**CITY OF TEMPLE, TEXAS
DRAUGHON-MILLER CENTRAL TEXAS REGIONAL AIRPORT**

TxDOT CSJ No. 2509TEMPL

ADDENDUM NO. 2

August 5th, 2025

2.0

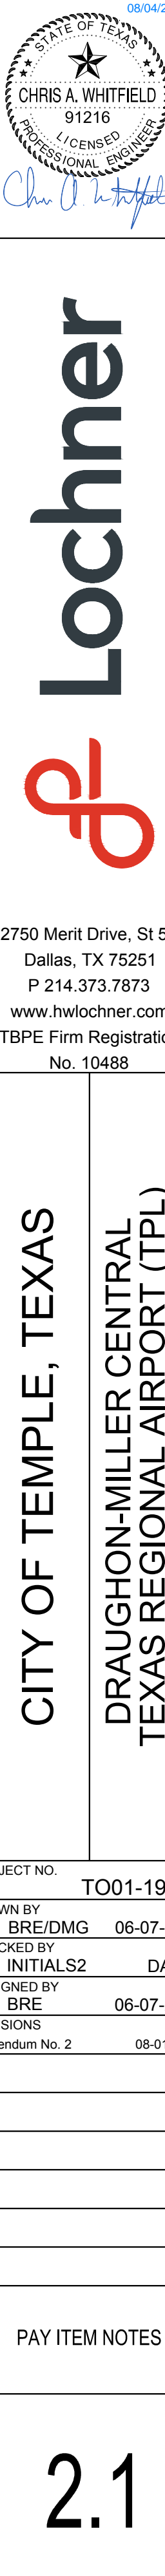
A note will be added to #10 Pavement Removal on plan sheet 2.1 "If an aggregate base is encountered, the removal of this material shall be subsidiary to the pay item "Remove Asphalt Pavement". This will also be addressed in the P-101 spec.

- d. If an Aggregate Base is encountered, the removal of this material shall be subsidiary to the Pay Item "Remove Asphalt Pavement" and disposed of off Airport Property. If base material is suitable and approved by the engineer it can be utilized as common fill. This effort will be considered subsidiary to P-152 embankment in place.
